# Access Compliance Report

## Public Rights-of-Way

Intersection ID: 42648	Main Street: JAKOBSON_DR	Cross Street: VALENDRA_DR	Location: NW
ADA ID: E2AC805F99F7	Ramp Type: PerpDiag	Initial Pass/Fail: Fail	Overall Compliance: No
Severity Score: 21.25			
Codes/Mitigation Info/Possible Solution		Field Measurements/Component Compliance

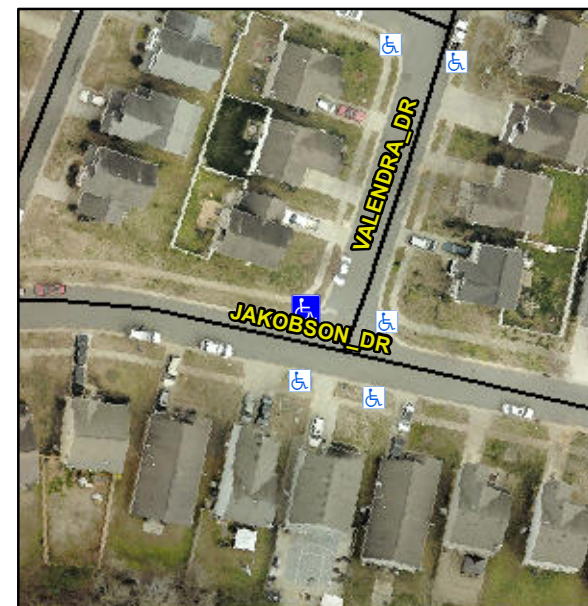
**Remove & Replace Curb Ramp With Two New Directional Ramps or Equivalent.**

**Not Found, R304.5.1, R304.5.3**

Compliance	Description	Data	Compliance	Description	Data
N/A	Ramp Length (in)	82.0	Yes	Ramp Slope (%)	8.0
No	Ramp Width (in)	38.0	No	Ramp XSlope (%)	5.8
N/A	Flare Type LT	N/A	N/A	Flare Type RT	N/A
N/A	Flare Slope LT (%)	N/A	N/A	Flare Slope RT (%)	N/A
N/A	Flare Traversable LT?	N/A	N/A	Flare Traversable RT?	N/A
N/A	Landing Length (in)	N/A	N/A	DWS Provided?	N/A
N/A	Landing Width (in)	N/A	N/A	DWS Contrast?	N/A
N/A	Landing Slope (%)	N/A	N/A	DWS Length (in)	N/A
N/A	Landing X Slope (%)	N/A	N/A	DWS Full Width?	N/A
N/A	Landing Curb? (Y/N)	N/A	N/A	DWS Offset (in)	N/A
N/A	Shared Landing?	N/A			
N/A	Gutter Ponding?	N/A	N/A	Gutter Slope (%)	N/A
N/A	Gutter Lip Ht (in)	N/A	N/A	Gutter X Slope (%)	N/A
N/A	Painted X Walk1?	No	N/A	Painted X Walk2?	No
	X Walk 1 Direction	To SE		X Walk 2 Direction	To E
N/A	X Walk 1 Width (in)	N/A	N/A	X Walk 2 Width (in)	N/A
	X Walk 1 Slope (%)	6.2		X Walk 2 Slope (%)	1.9
	X Walk 1 X Slope (%)	3.6		X Walk 2 X Slope (%)	1.0
